UNITED STATES PATENT AND TRADEMARK OFFICE

APPLICATION NO.	FILING DATE	FIRST NAMED INVENTOR	ATTORNEY DOCKET NO.	CONFIRMATION NO.
09/751,453	01/02/2001	Kee Jeung Lee	M 275264 HD943/US	7152

Office Action Summary

However, DeBoer in fig.3 shows

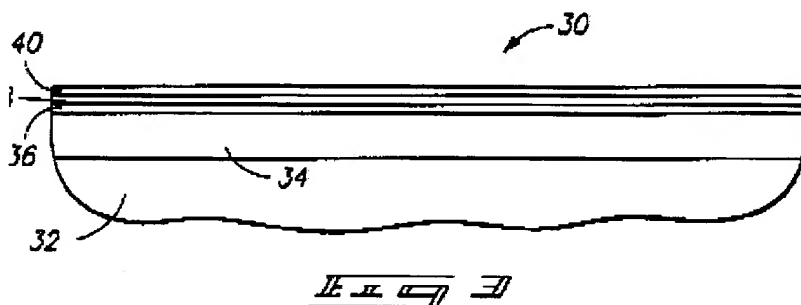
Applicants' next contend that " DeBoer does not teach or suggest that an amorphous TaON thin film is formed on the lower electrode as recited in claim1".

Therefore it is known in the prior art that the dielectric layer may comprise of a plurality of layers.

It is noted that the previous rejection referred to layer (namely # 40) and layer 38 mentioned by the applicants.
